Adequacy Review for Midwestern Farms TR-05

There are several things in the letter that CPW needs to address as follows (comment numbers are from Amy's letter):

Rec Plan Map 4-6-16.PDF
680K

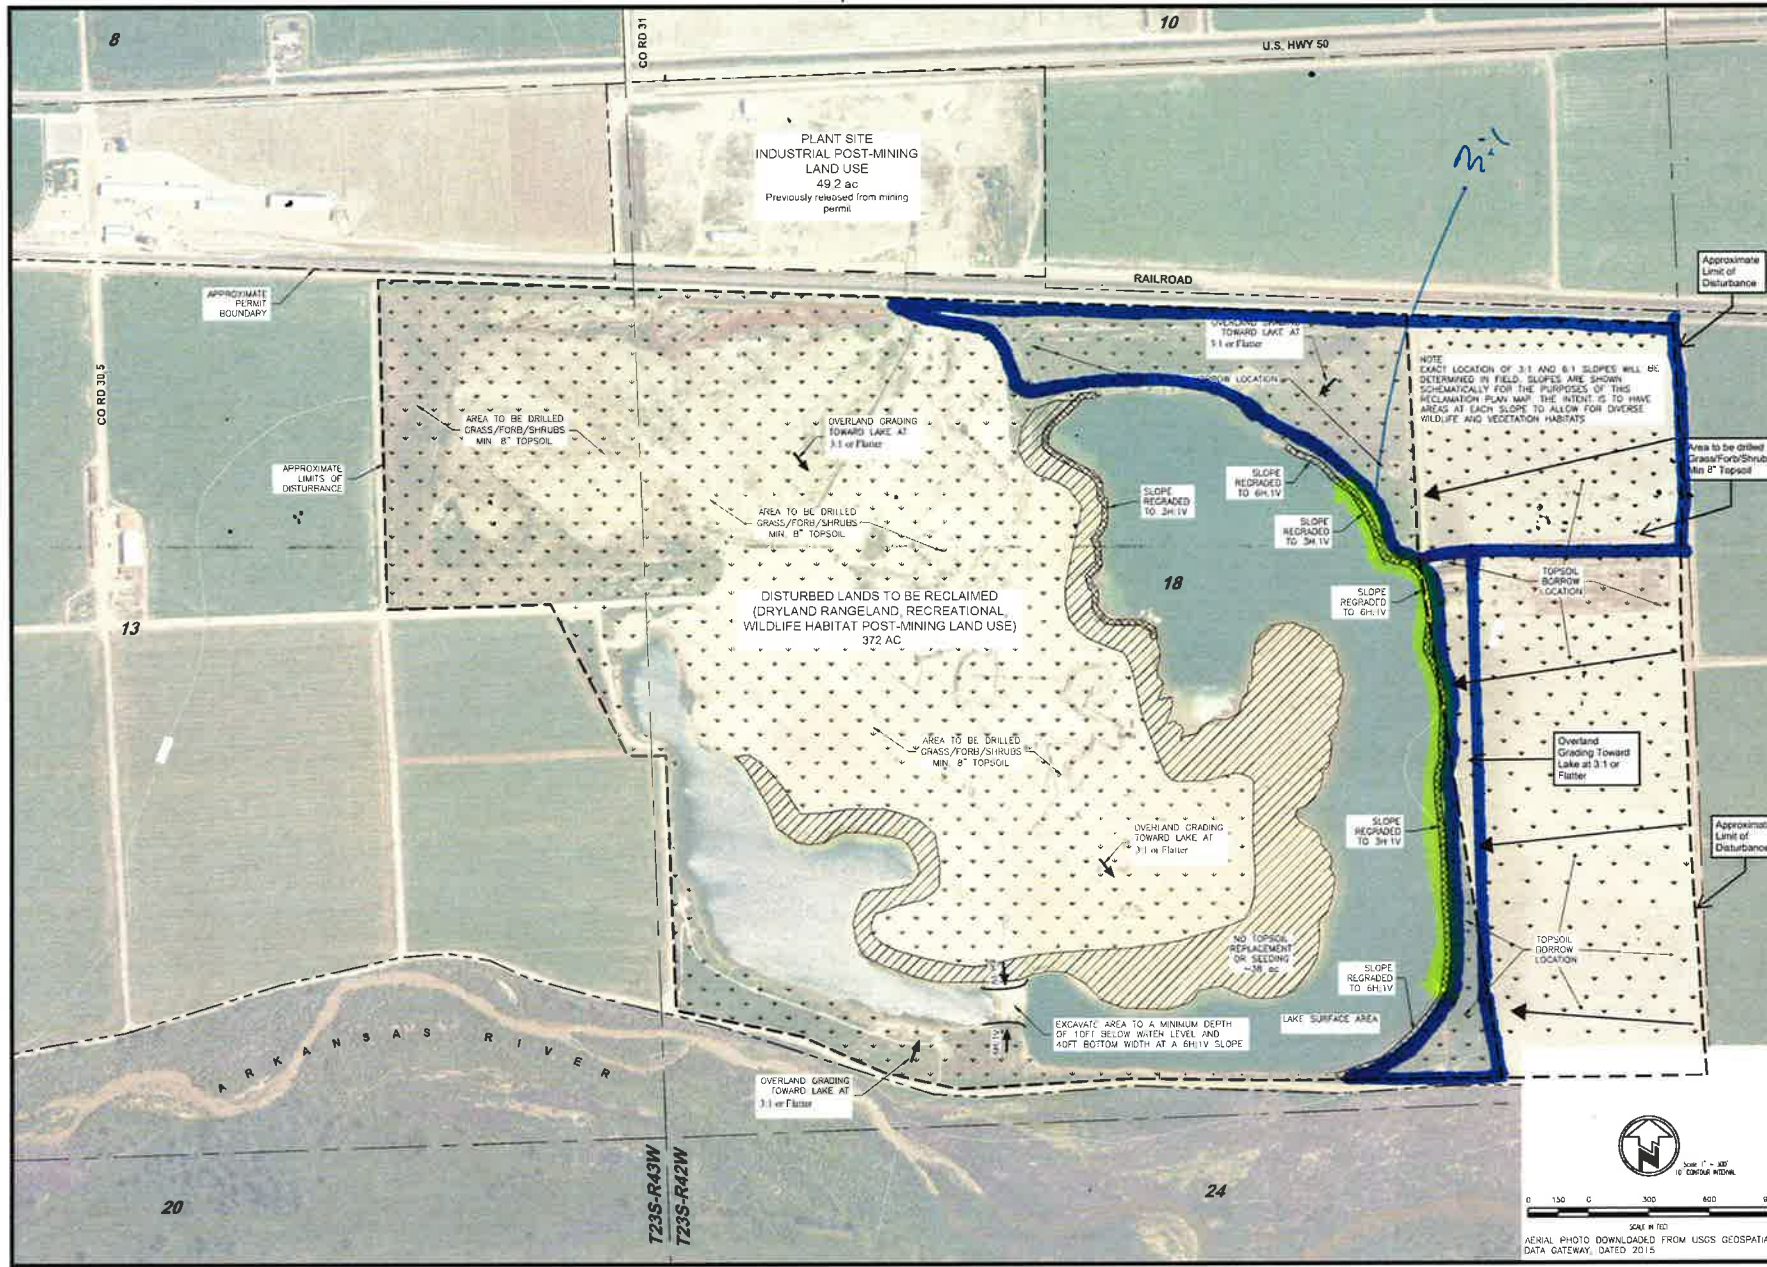
1. Overland Grading Toward Lake at 3:1 - not sure when this revision first appeared, but attachment #2 to this email shows an earlier version that CPW approved of that has grading at 3-5% towards the lake. We do not approve of 3:1.
2. "Topsoil Borrow Location" is shown all along the east side of the lake, which is what had been proposed by ECA/Midwestern months ago, but CPW did not agree to that - we agreed to the areas outlined in blue in map #1 attached. Thus, that needs to be shown on the final TR map.

Exhibit F

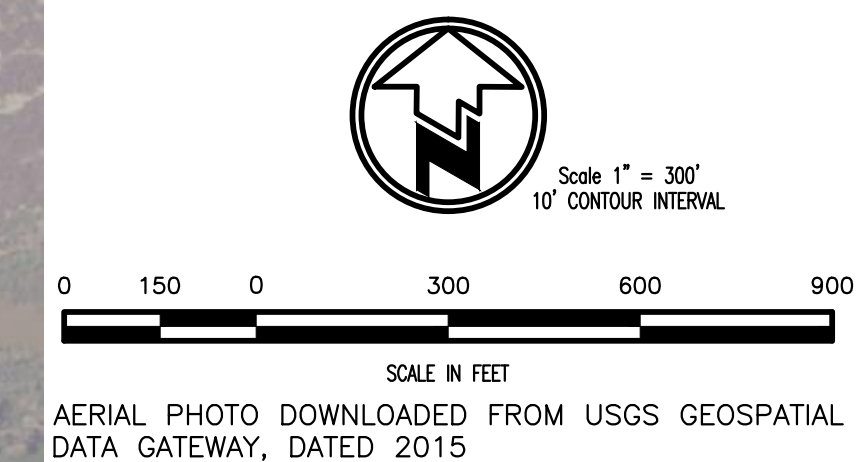
There are 2 errors on the TR map provided by ECA (3rd attachment to this email) that need to be amended:
